Access Compliance Report Public Rights-of-Way (Curb Ramps)

Main Street: SPUR_LN Cross Street: MARTHA_ANN_DR Location: E

ADA ID: RPRK211207114350 Ramp Type: Type 1 - Perpendicular Diagonal Initial Pass/Fail: Fail Overall Compliance: No Severity Score: 2

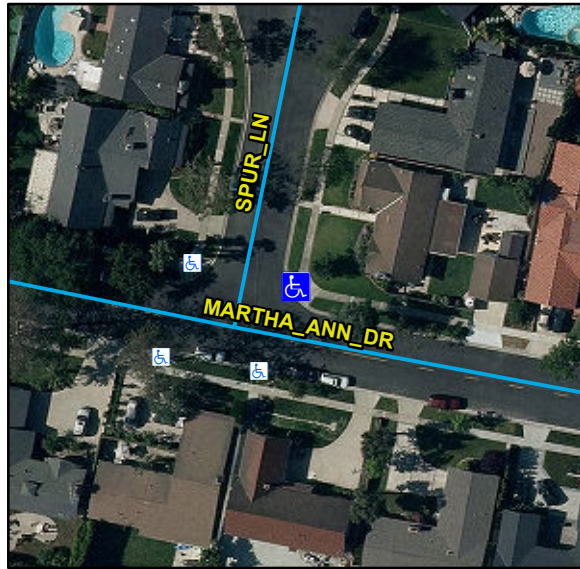
R304.2.2, R204.3, R304.5.3, STD 1115

Remove & Replace Curb Ramp With Two New Directional Ramps or Equivalent.
